COMMISSION DIRECTIVE 2010/26/EU

of 31 March 2010

amending Directive 97/68/EC of the European Parliament and of the Council on the approximation of the laws of the Member States relating to measures against the emission of gaseous and particulate pollutants from internal combustion engines to be installed in non-road mobile machinery

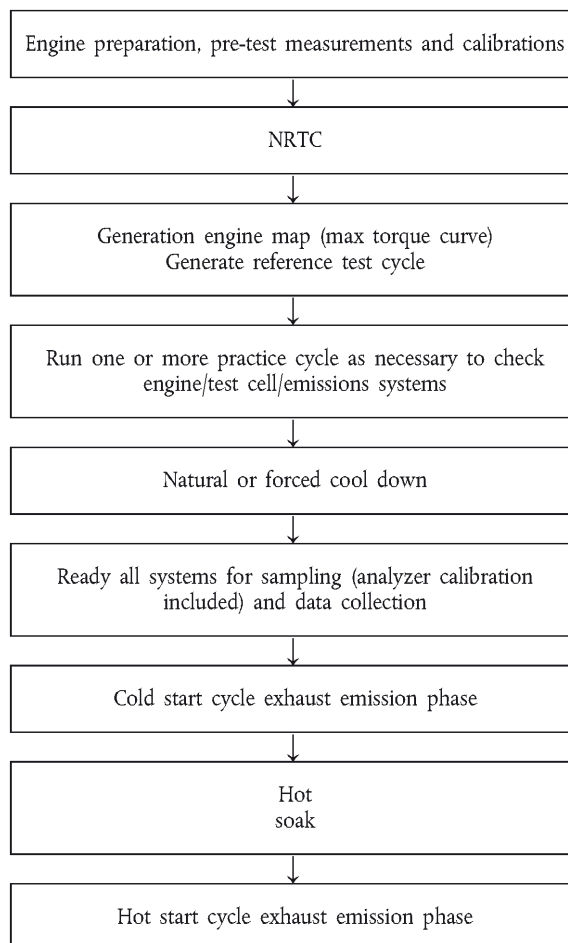
5. Section 4.5 is replaced by the following:

4.5. Emissions test run

The following flow chart outlines the test sequence:
